UNITED STATES PATENT AND TRADEMARK OFFICE

APPLICATION NO.	FILING DATE	FIRST NAMED INVENTOR	ATTORNEY DOCKET NO.	CONFIRMATION NO.
10/735,374	12/12/2003	Betty Shu Mercer	TI-36853	1822

Office Action Summary

DETAILED ACTION

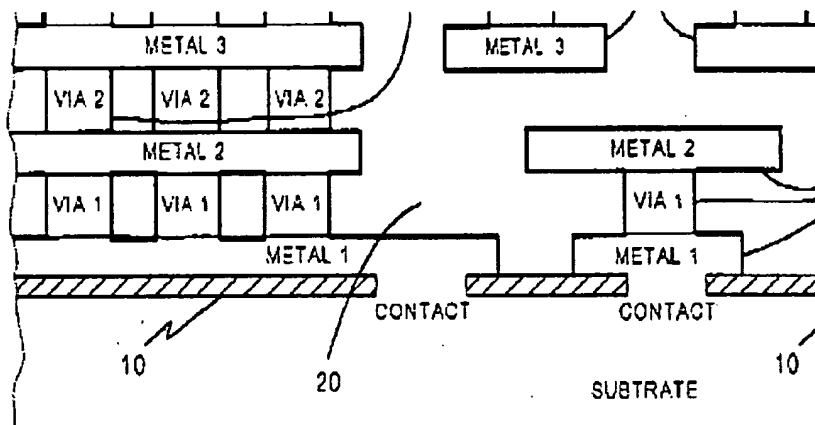
9. Regarding claim 33, Jeong in view of Thomas show that the metal plugs couple at least one of the thick copper connections to one of the metal regions.

10. Regarding claim 34, Jeong in view of Thomas shows that the thick copper substantially overlies at least one of the metal regions.
